# Mobile Intel® Pentium® 4 Processor - M

## Specification Update

*April 2004*

Document Number: 250721-022

**Figure 13. System Bus Reset and Configuration Timings**

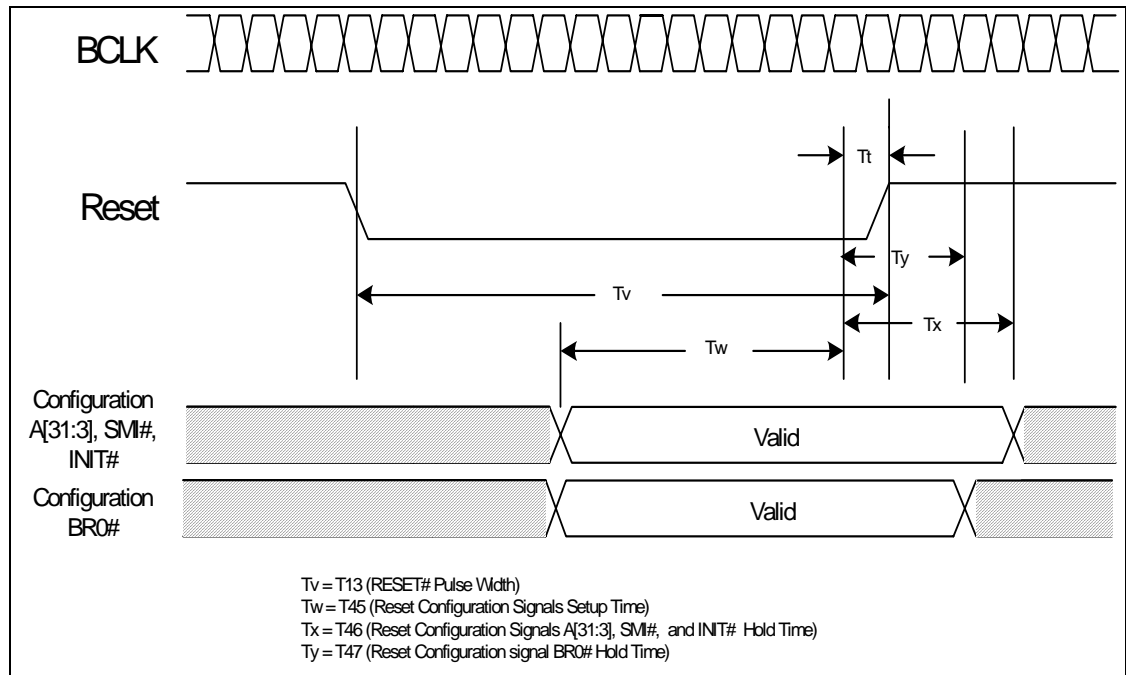
The BR0# maximum hold time has changed to 2 BCLKs. This change will be shown in the “System Bus AC Specifications (Reset Conditions)” table and “System Bus Reset and Configuration Timings” figure of the *Mobile Intel® Pentium® 4 Processor - M Datasheet*. This change will be incorporated in the next revision of the datasheet.

The following figure will be modified to reflect this change:

T# Parameter	Min	Max	Unit	Figure	Notes
T45: Reset Configuration Signals (A[31:3]#, BR0# INIT#, SMI#) Setup Time	4		BCLKs	13	1
T46: Reset Configuration Signals (A[31:3]#, INIT#, SMI#) Hold Time	2	20	BCLKs	13	2
T47: Reset Configuration Signal BR0# Hold Time	2	2	BCLKs	13	2
